12 December 2016

TH347-01F04 Addendum to DA Acoustic Report (r4)

## North Plot, The Darling Exchange - Addendum to SSDA10 Acoustic Report

*Loading Zones C and F removed*

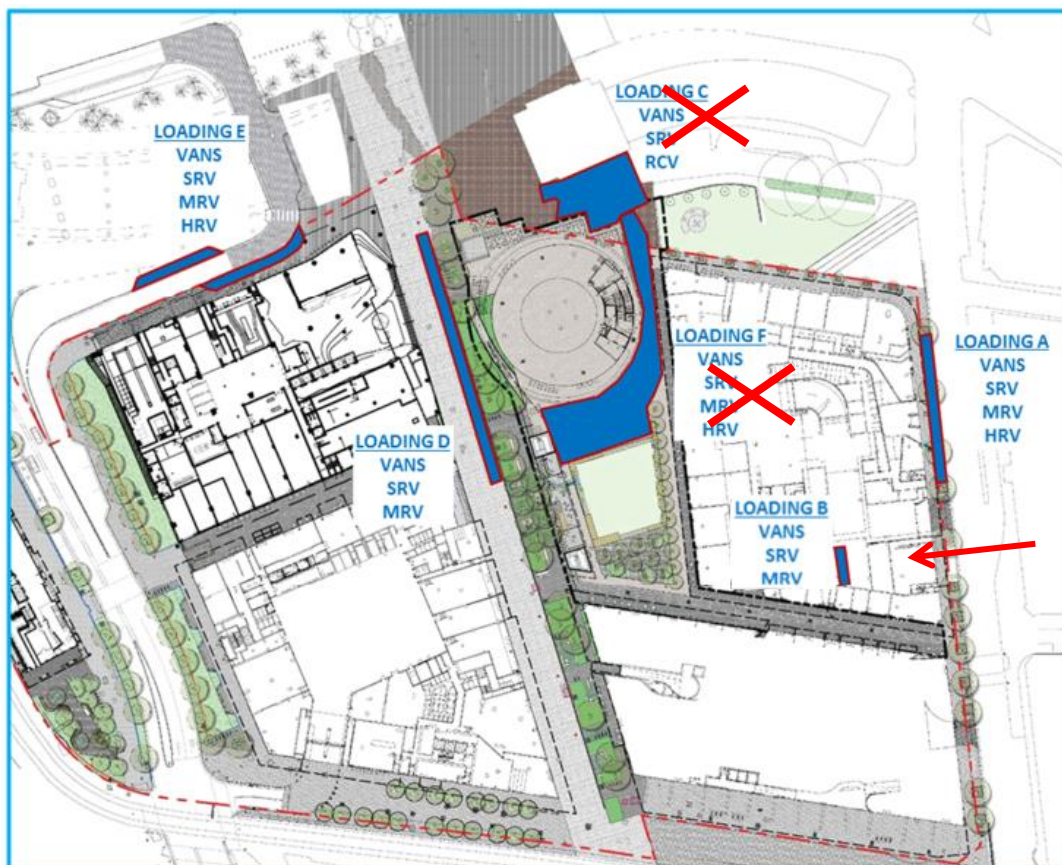
**Query:** *The Noise and Vibration report (Appendix P) includes a loading matrix that suggest loading times up to 8pm, however, the loading service area assessment suggests a limit of 10pm. Provide confirmation of exact expected loading times, whether any loading is proposed after events ending at 10pm in the square and how the noise from any such loading will be managed/minimised if proposed.*

**Query:** *Confirm what additional mitigation measures can be used to reduce the impact of noise from outdoor events within the public square on residential properties.*

**Response:** The loading strategy has been amended since the lodgement of the Development Application. Loading for the North Plot will now be serviced through the North East Plot (Loading area B) with loading for the public domain and events now occurring primarily through the boulevard (Loading Area D) with support via Theatre Access Lane (Loading Area E). This has removed loading zones F and C directly outside the North East Plot and Novotel that were identified in the original report as sensitive with regard to noise sensitive receptors.

As noted in the original report Loading Area D will also need to be managed with regard to potential impacts within the Darling Square development. In particular, the SW Plot and SE Plot will need to be considered. Medium and large scale events will require future approvals with Place Management NSW (formally known as SHFA). Attached to the detailed application on an event by event basis, there will be a specific Plan of Management provided which will deal with key acoustic mitigation measures for event types. A general Plan of Management is provided with this RTS that recommends bump out for events finishing after 10pm to occur the next morning to minimise impact on surrounding properties.

**Figure 1: Up to 10pm operation**

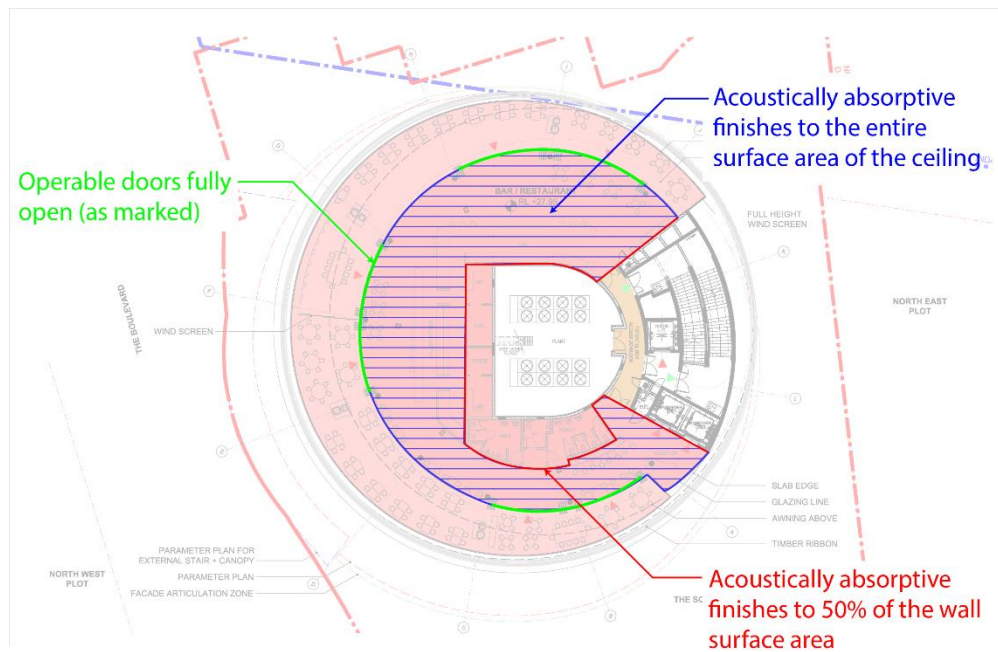
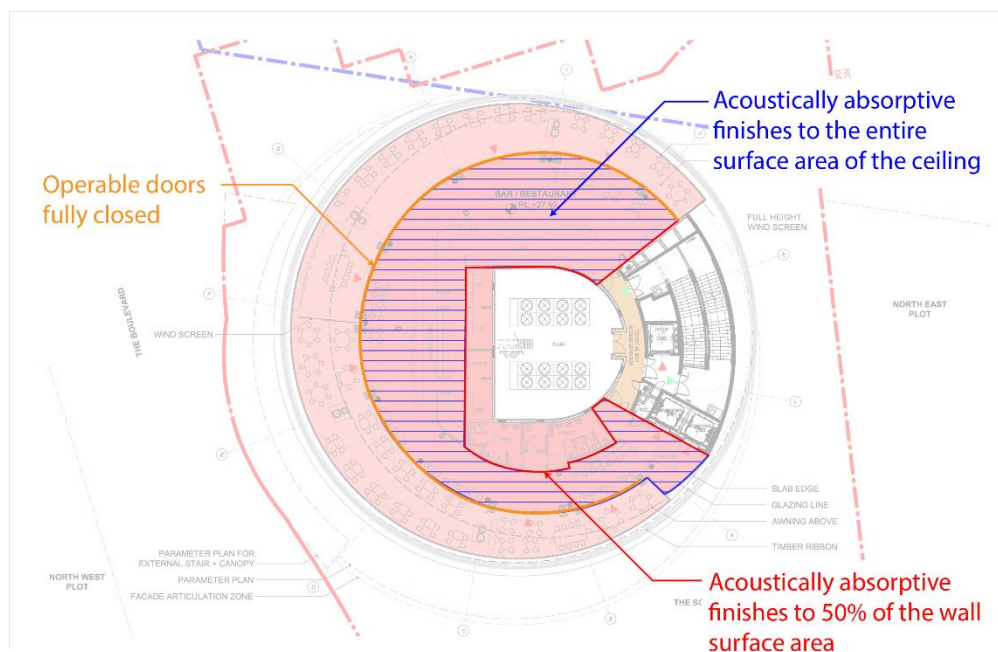
**City of Sydney Query:** "... The BCA Report lodged indicates the roof level restaurant and bar could be occupied by up to 689 patrons and the child care centre, with 90 spaces, would be operating until 7.00pm..."

**SHFA Query:** It is noted that the proposal includes a rooftop restaurant and bar in addition to community facilities and markets. This appears to be inconsistent with the original purpose of the building on the North Plot and inappropriate to the location given.

It is recommended that the following acoustic measures are incorporated into the fit out during detailed design to enable outdoor areas to be fully occupied up to 10pm with a maximum of 280 patrons and indoor areas to be fully occupied with a maximum of 120 patrons to ensure compliance with the CoS Council's Standard Conditions of Consent for licensed premises. We recommend the absorptive material achieve a minimum NRC rating of 0.9.

Acoustically absorptive finishes to be applied to:

- The entire surface area of the ceiling with the exclusion of kitchen and bathroom areas
- Acoustically absorptive finishes should be provided to 50% of the internal wall surface area (ie. kitchens and bathroom walls)

100% of the operable facade could be open with the implementation of sound limiting devices. If sound limiting devices are not implemented during detailed design, only 50% of the operable facade could be open.
